PLANNING

Client: Rebecca Nichols
 Drawing Number: **P404_110**
 Drawing Title: **Propos. Attic and Roof Plan**
 Date: 24/04/2025
 Scale: 1:100 @ A4

P404_ 128 Old Lansdowne Road

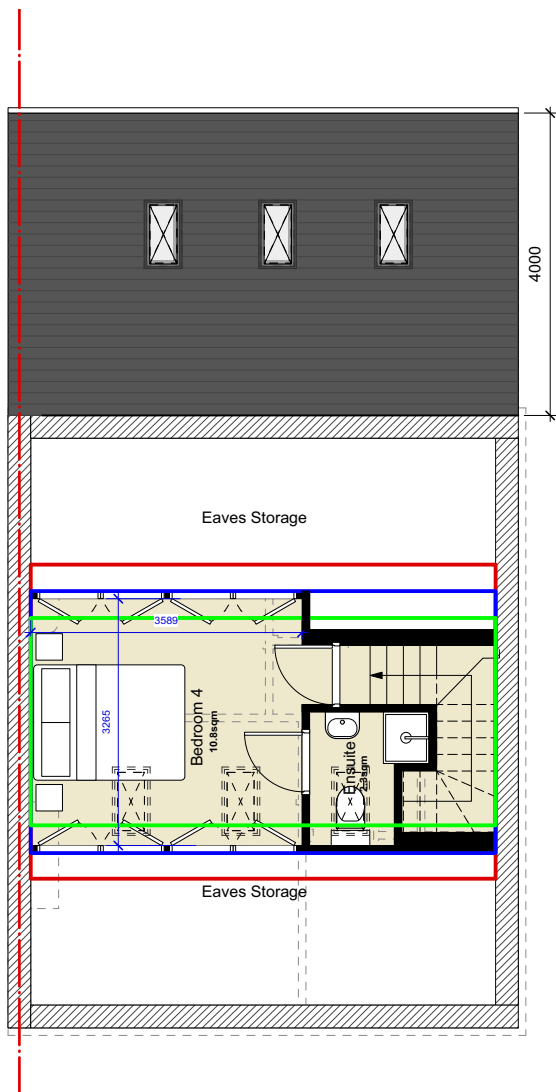
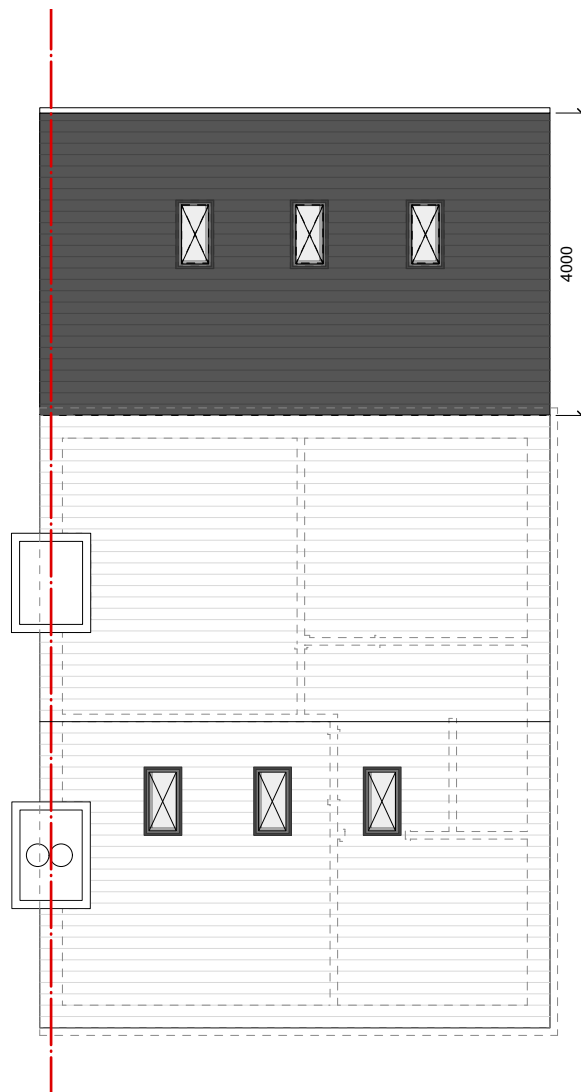
A 05/09/2025 Drawing status updated to Planning. Extension depth reduced to 4m in response to planner's comments dated 02.09.2025.
